# IRC - Building

## 2016 GROUP B PUBLIC COMMENT AGENDA

OCTOBER 19 - OCTOBER 25, 2016  
KANSAS CITY CONVENTION CENTER  
KANSAS CITY, MO

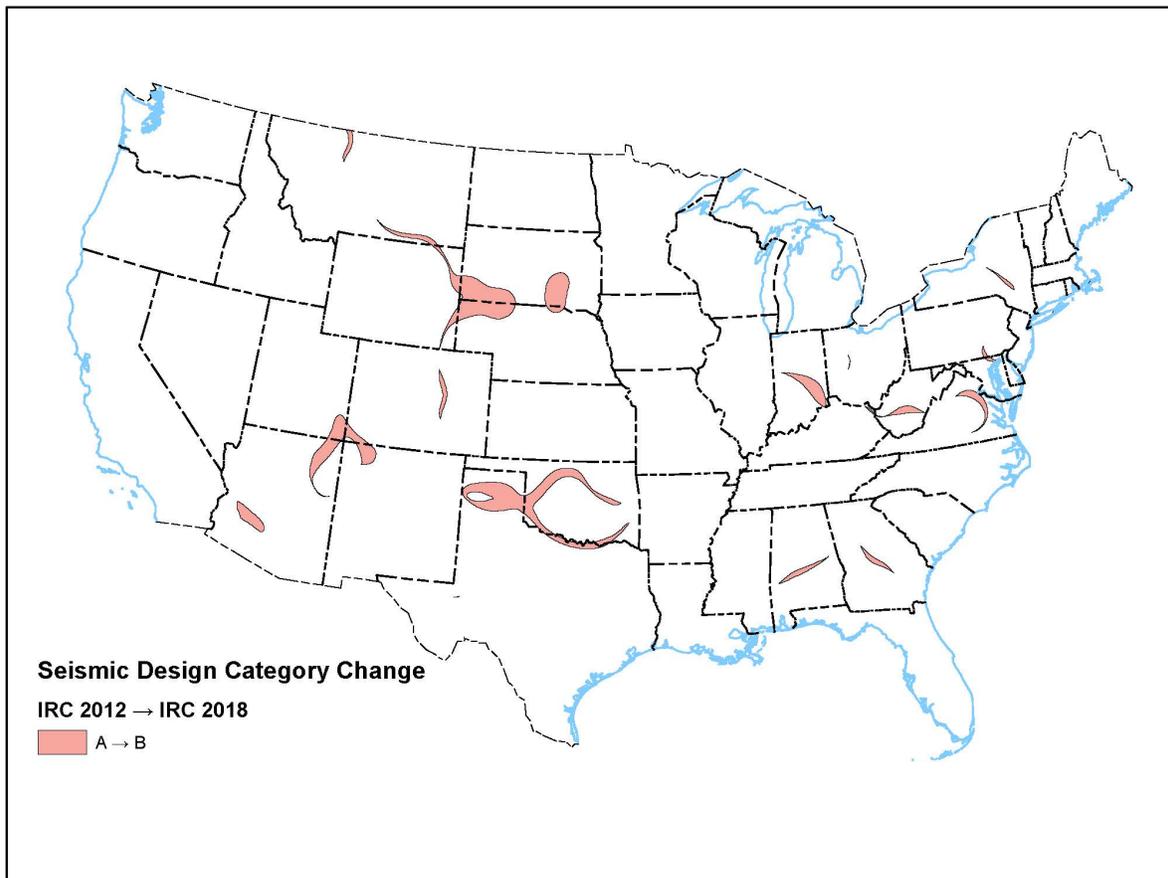
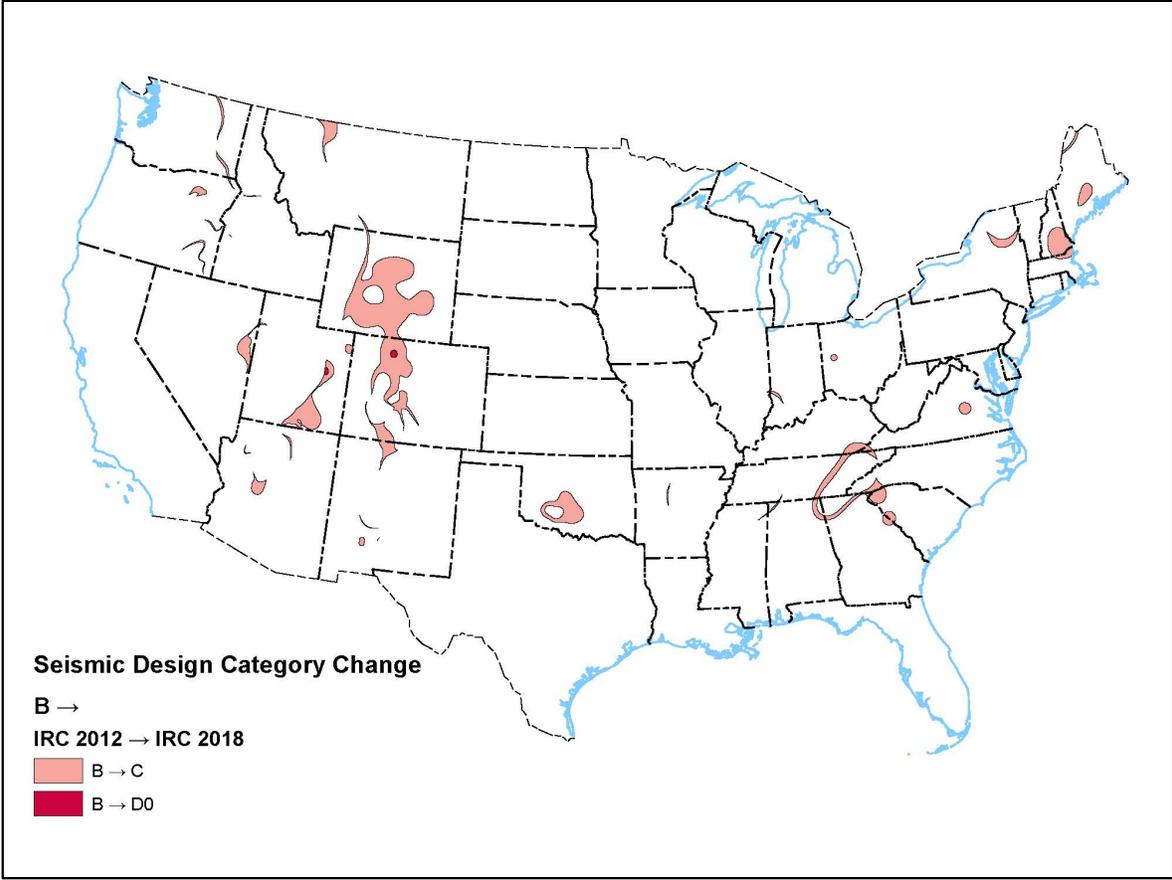
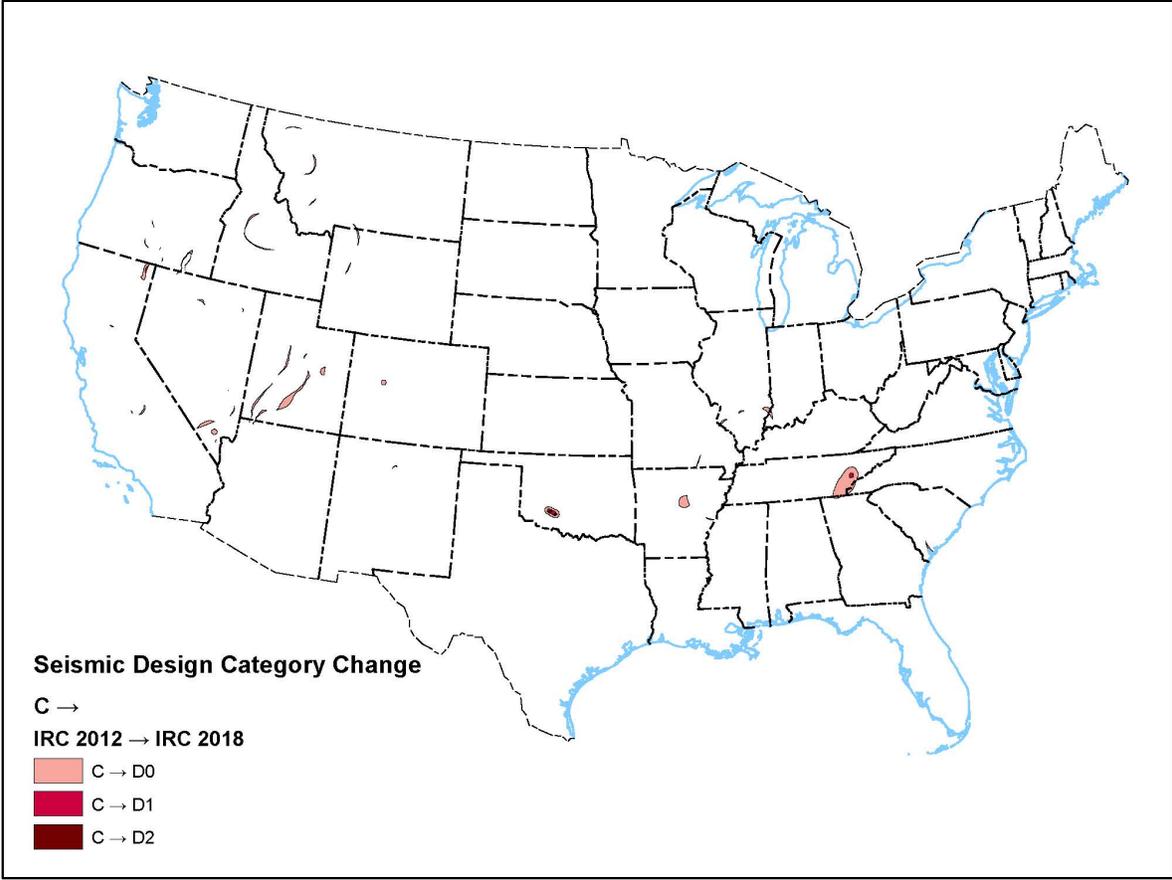
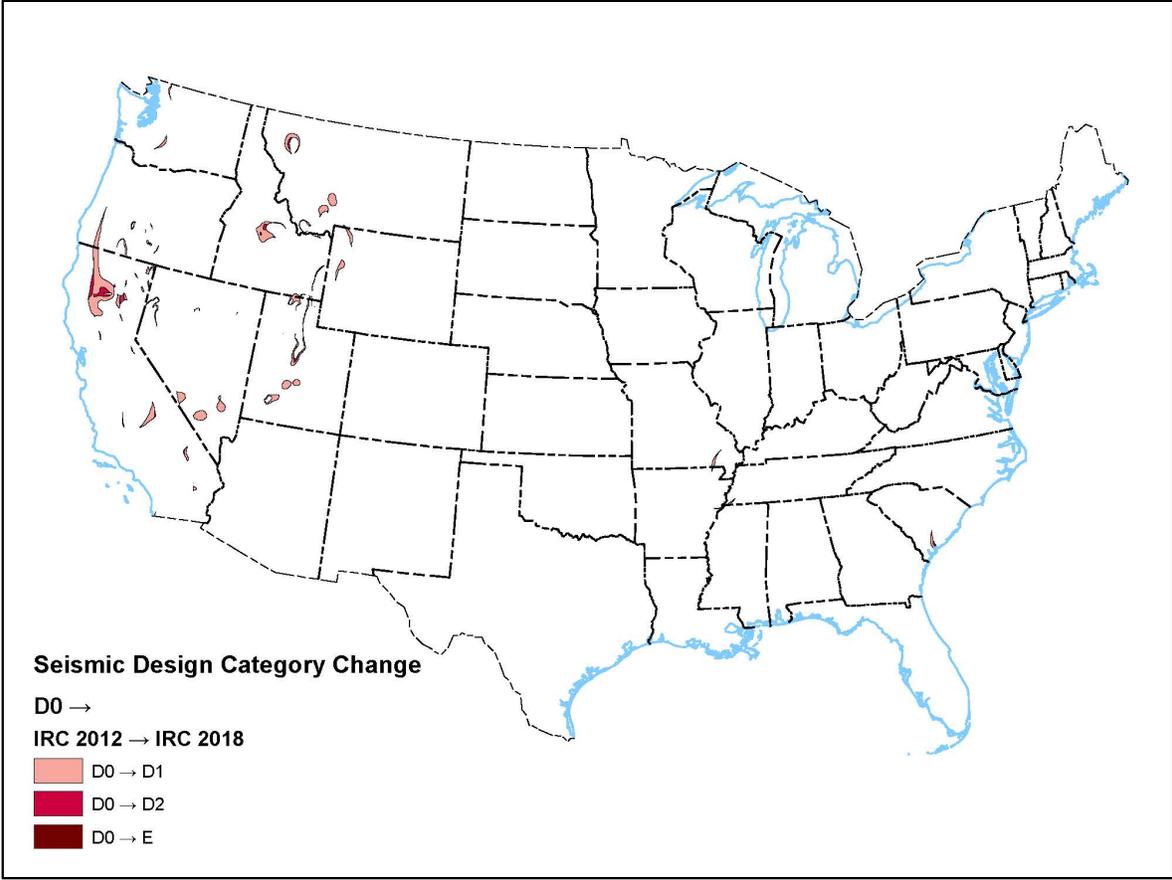
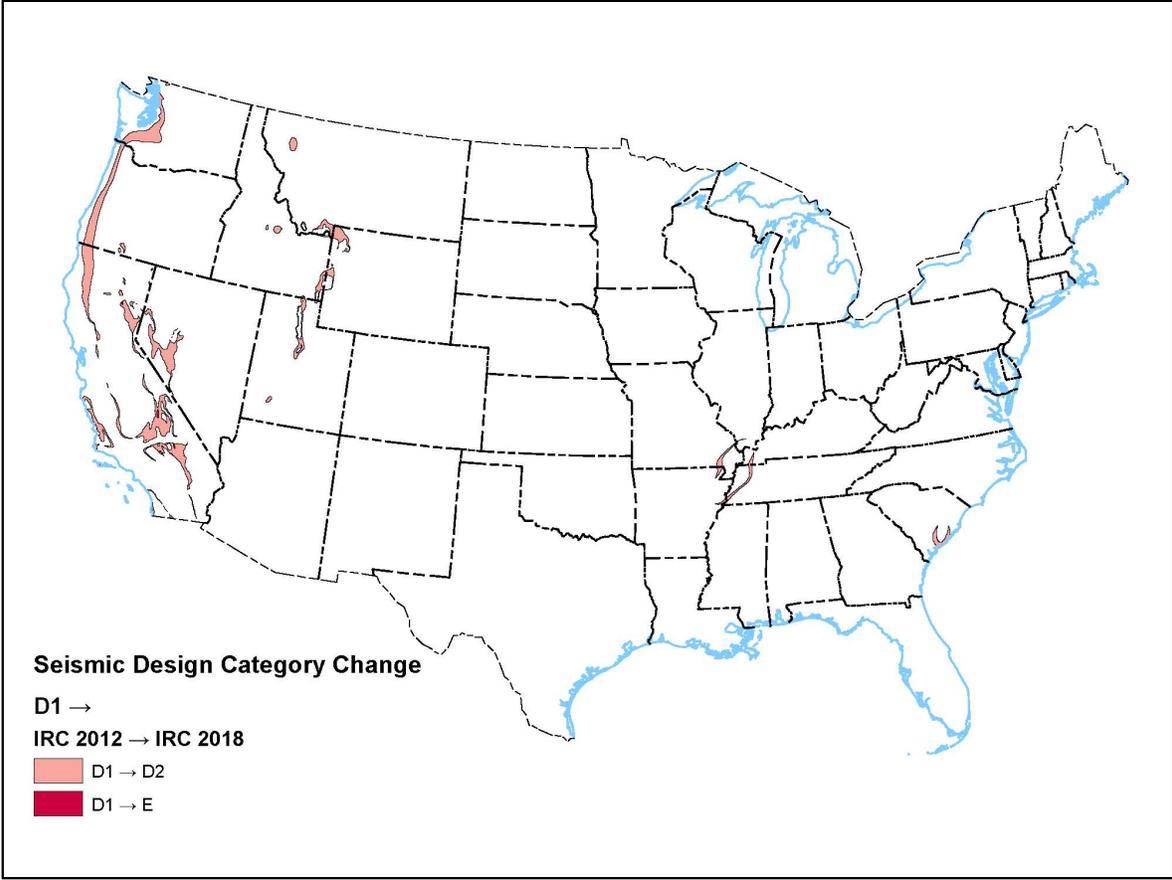
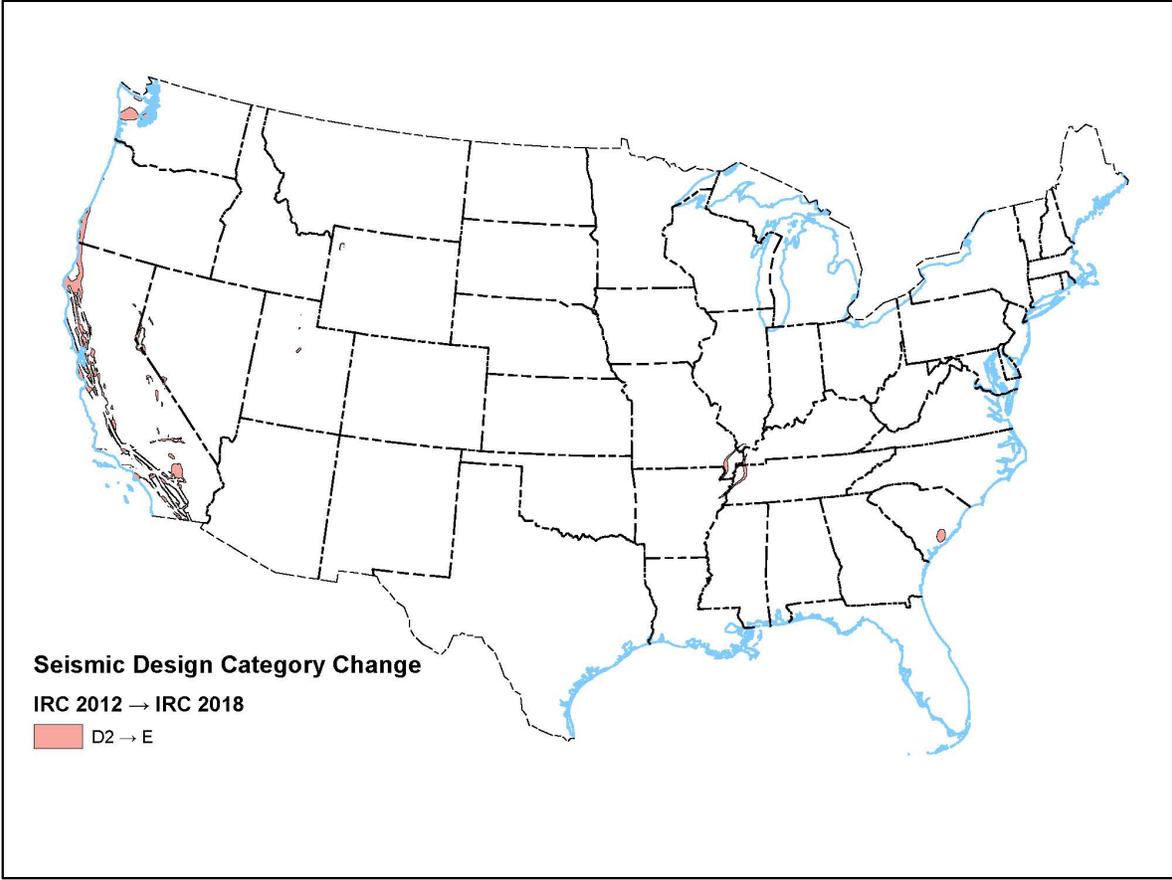
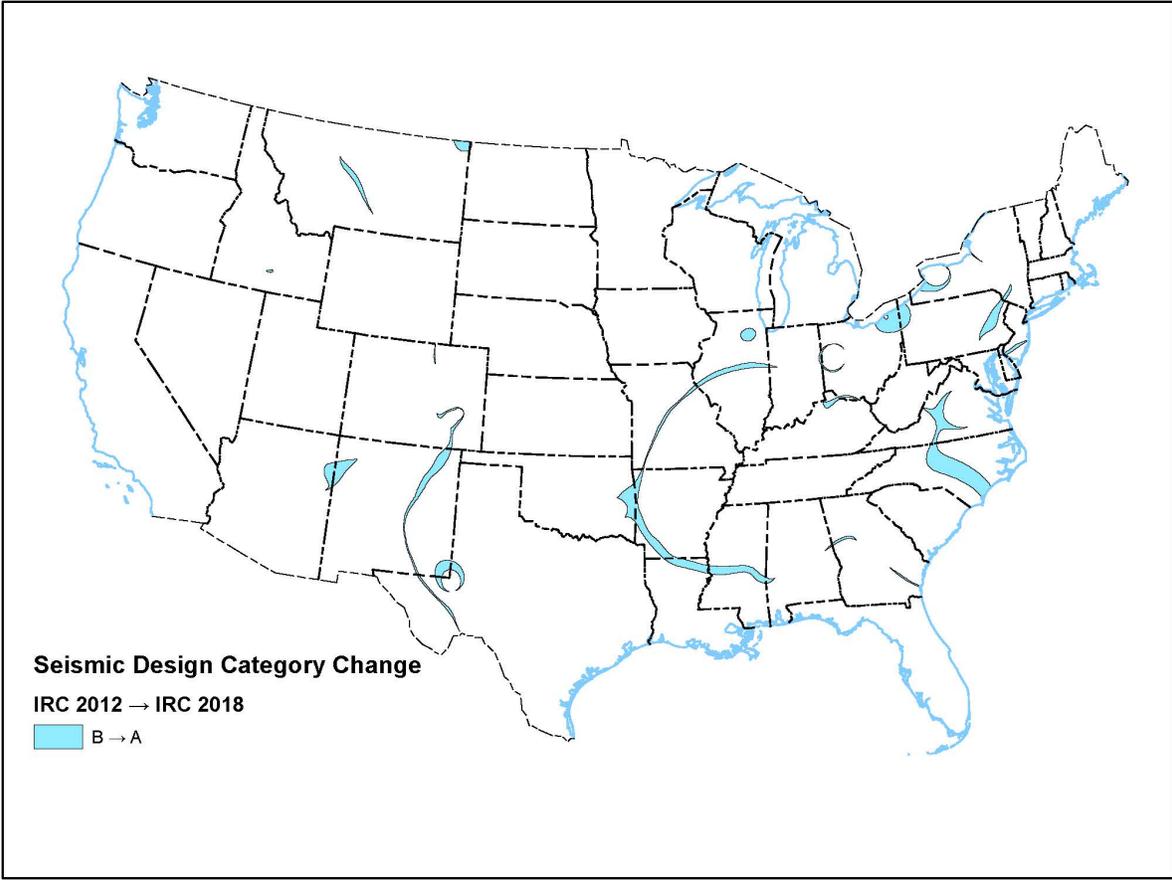
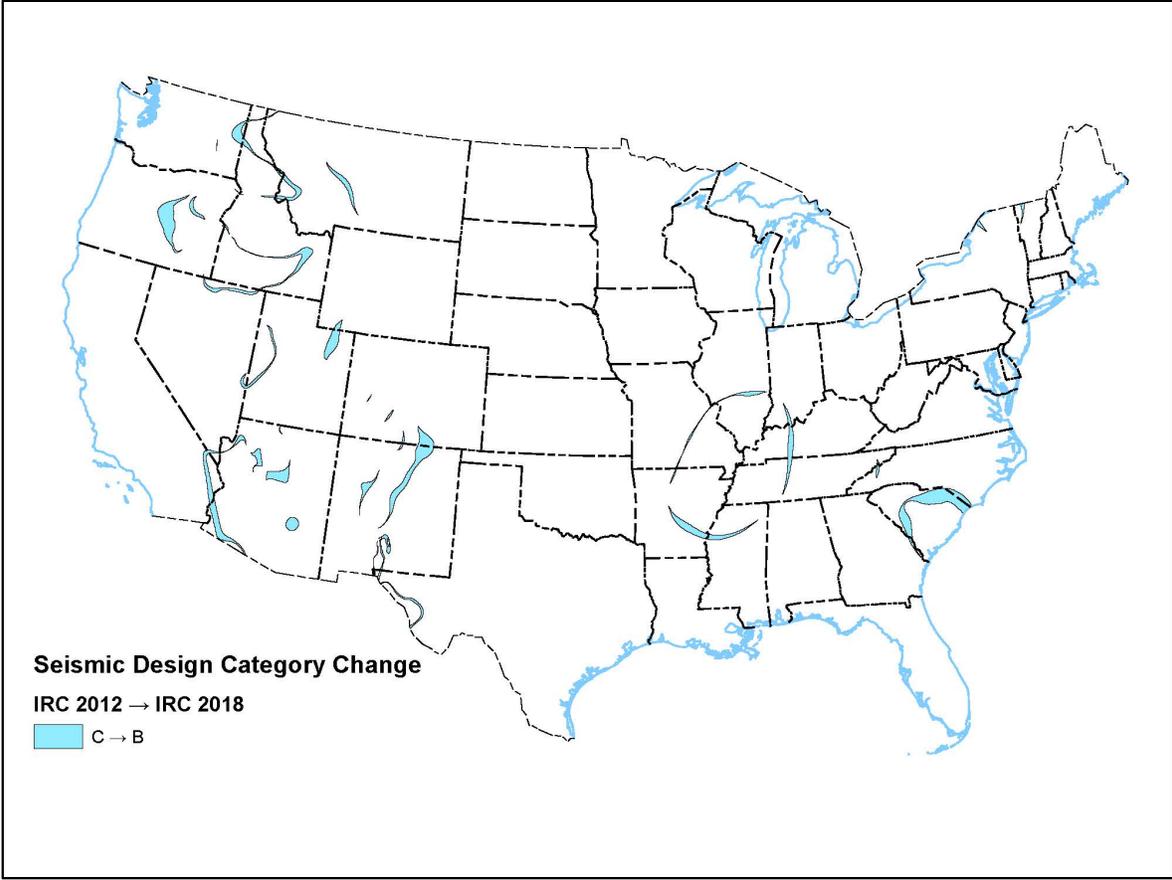
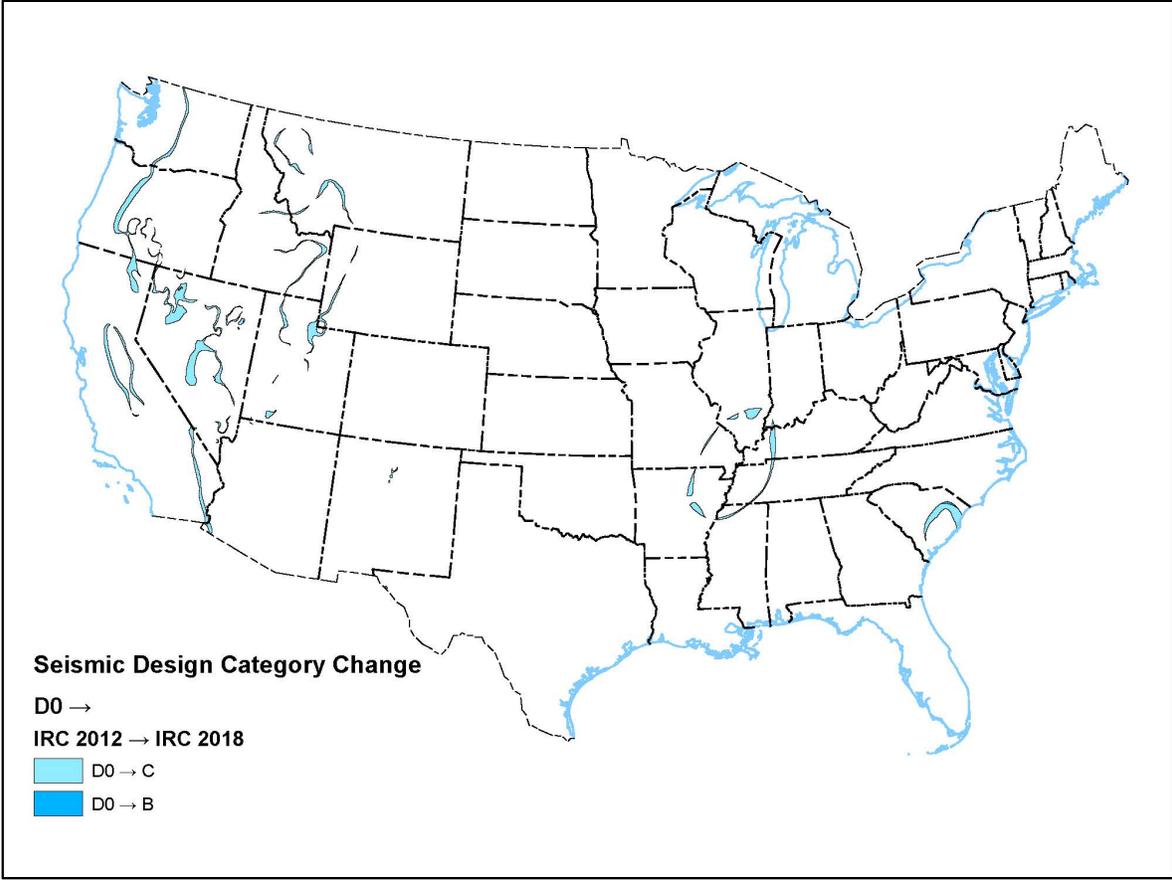
Maps have been developed by USGS to illustrate locations where Seismic Design Categories increase and decrease when comparing the 2015 IRC maps to the R301.2(2) default maps. These are included as an attachment to this code change proposal. Seyhan and Stewart (2014) and Luco et al. (2015) provide discussion of maps changes at some specific locations, including a region near Charleston, South Carolina where Seismic Design Category increased from D<sub>2</sub> to E. This increase is due to changes in both site coefficients and mapped ground motions, the latter due to an improved earthquake source model for the Central and Eastern United States developed through a three and one-half year collaboration of approximately 35 experts (<http://www.ceus-ssc.com>).

This code change can result in modest increases OR decreases in construction cost depending on geographic region. Where the R301.2(2) Seismic Design Category maps are used, limited locations as illustrated by the attached USGS maps, will increase or decrease in Seismic Design Category, increasing or decreasing seismic bracing requirements and cost a modest amount. The amount of increase will vary depending on the specific change in Seismic Design Category, the wind bracing requirements, and the particulars of the dwelling and its construction. In some cases increases in Seismic Design Category and resulting cost can be reduced if not eliminated where the site soils allow the use of the Alternate Seismic Design Category maps. NIST GCR 14-917-26, *Cost Analyses and Benefits for Earthquake-Resistant Construction in Memphis, Tennessee*, provides one example of the magnitude of seismic design cost impact; the increment in cost for apartment building construction between design for code-required wind loads and national seismic design provisions is on the order of one percent of construction cost.
